MFN 06-232

**Subject: Response to Portion of NRC Request for Additional Information Letter No. 31 Related to ESBWR Design Certification Application – TRACG Application for ESBWR ATWS – RAI Numbers 21.5-1, 21.6-5, 21.6-6, 21.6-9, 21.6-33, 21.6-39, 21.6-40, and 21.6-47**

**Response to NRC Request for Additional Information**

**PIRT Ranking of ESBWR Suppression Pool Equalization Line**

Figure 1: RPV and Drywell Water Levels for BDL Break (12 hours)

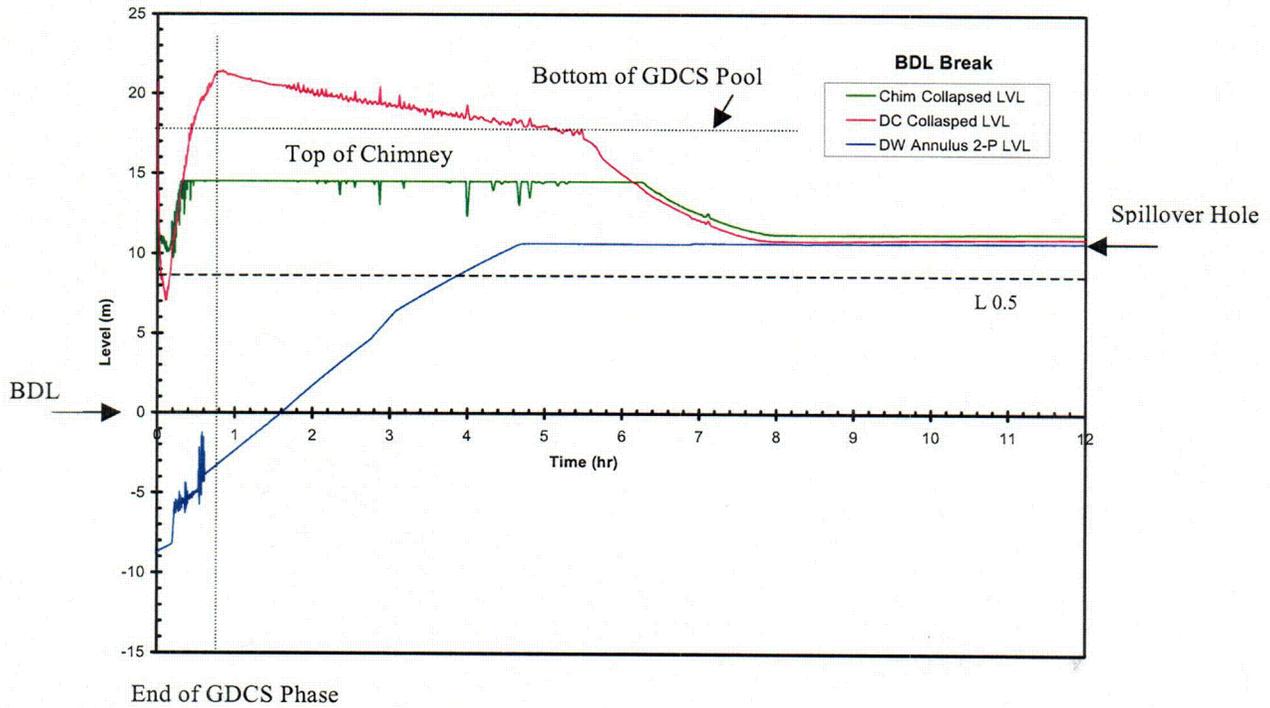
*The NRC SER approving NEDE-33083P, TRACG Application for ESBWR, Confirmatory Item 1 stated that an appropriate long term cooling PIRT must be provided at the design certification stage. ESBWR DCD, Tier 2, Tables 6.3-7 through 10 indicate that the reactor pressure vessel (RPV) level will remain above Level 0.5 for the feedwater line break (FWLB), main steam line break (MSLB), gravity driven cooling system line break (GDLB), bottom drain line break (BDLB) and, therefore, the suppression pool equalizing line valves are not expected to open. GE submittal MFN 05-096, states that a long term PIRT will be provided. GE submittal MFN 05-105 provides a long term PIRT which lists the equalizing line (EQ) importance as "N/A". GE submittal MFN 05-109 indicates in Table 2, "Containment/LOCA long term PIRT," that the equalizing line (EQ1) friction is ranked "High". Clarify the importance of the equalizing line for long term cooling in the DCD and describe appropriate testing (i.e., qualification testing and inspection test analyses and acceptance criteria (ITAAC)).*

As stated in the DCD Tables 6.3-7 through 10, the equalization line valves are not expected to open for a Loss of Coolant Accident (LOCA) resulting from a break in any of the lines in the current ESBWR design. Figures 1, 2, 3 and 4 (from MFN 05-105) show the downcomer level response for the first 12 hours following a bottom drain line break, feedwater line break, GDCS line break and main steam line break respectively. The figures show that the downcomer water level stabilizes at an elevation well above the elevation of the L0.5 trip (1 m above top of active fuel and approximately 8.5 m above the bottom of the RPV). The lowest level in the long term occurs for the GDCS line break, which still has more than 1 meter margin to L0.5. This is the consequence of two changes in the current design relative to the design analyzed in NEDE-33083P: a larger GDCS pool volume and smaller lower drywell volume.

The long term LOCA PIRT shown in MFN 05-105 for the RPV correctly states the importance of the equalization line (EQ) as N/A.

Table 2, "Containment/LOCA long term PIRT," in MFN 05-109 shows an incorrect 'High' ranking for equalization line friction (EQ1). This table was extracted from a previous report, which did not reflect the changes in the ESBWR design mentioned above. The ranking for EQ1 should be 'N/A' because the equalization line valves will not be activated for any design basis events.
